Memorandum

Subject: Case File: 19-225732-000-00-LU SW BOND Avenue/SOWA Alamo Manhattan Blocks
Otak Responses to Land Use Review Comments dated November 21, 2019

Otak Project No.: 19050.100

DRIVEWAY DESIGN EXCEPTION EXHIBIT - B41 & B42

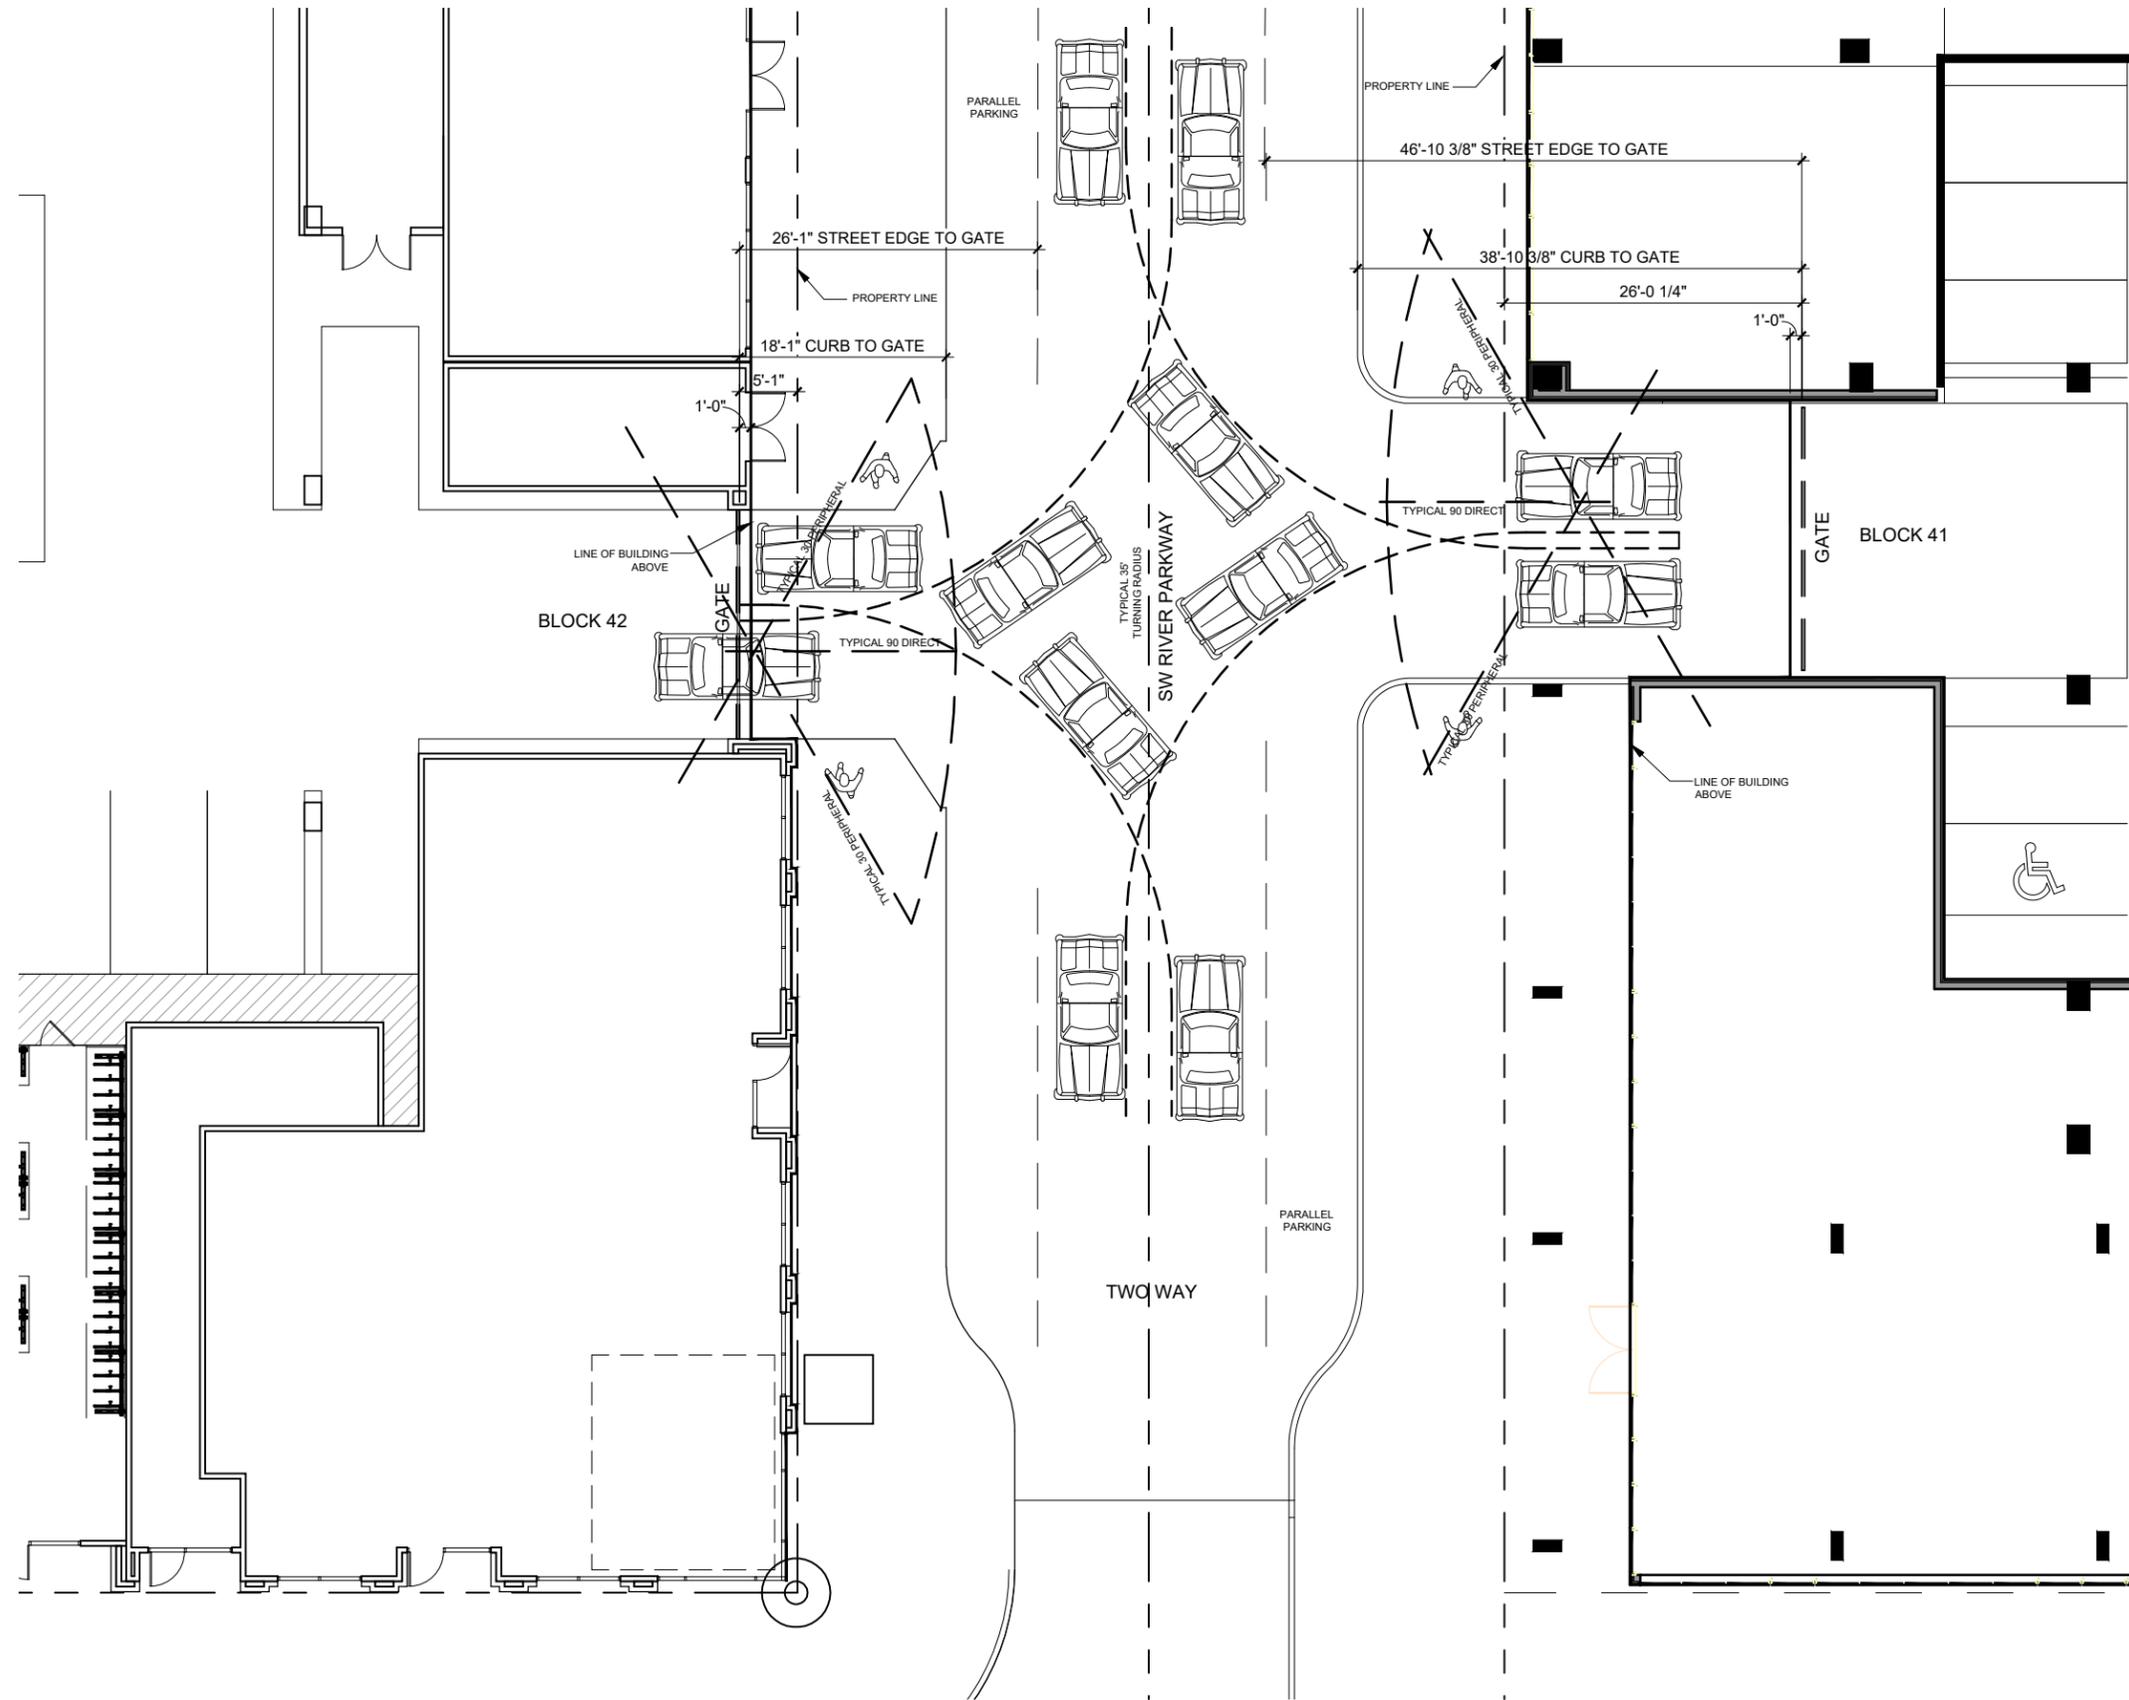
...Unfortunately, PBOT cannot support the DDE at this time based upon the current proposed locations of the driveways. PBOT is working with the applicant's traffic engineer to modify the driveway locations which could include shifting the driveway for Block 41 northward to align with driveway proposed to serve Block 42...

The driveway location for Block 41 has been shifted northward by approximately 26-feet. This shift creates a 12-foot separation between the centerline of Block 42 driveway (west side of River Parkway) and the centerline of Block 41 driveway (east side of River Parkway). This eliminates the conflict of simultaneous left-turn movements for vehicles turning into the garages. A revised driveway alignment plan for B41/B42 was provided to PBOT (Amanda Owings) on January 3, 2020. This plan is also attached to this response memo. Upon review/approval of the driveway alignment, PBOT will proceed with review of DDE submittal on vehicle access gate locations.
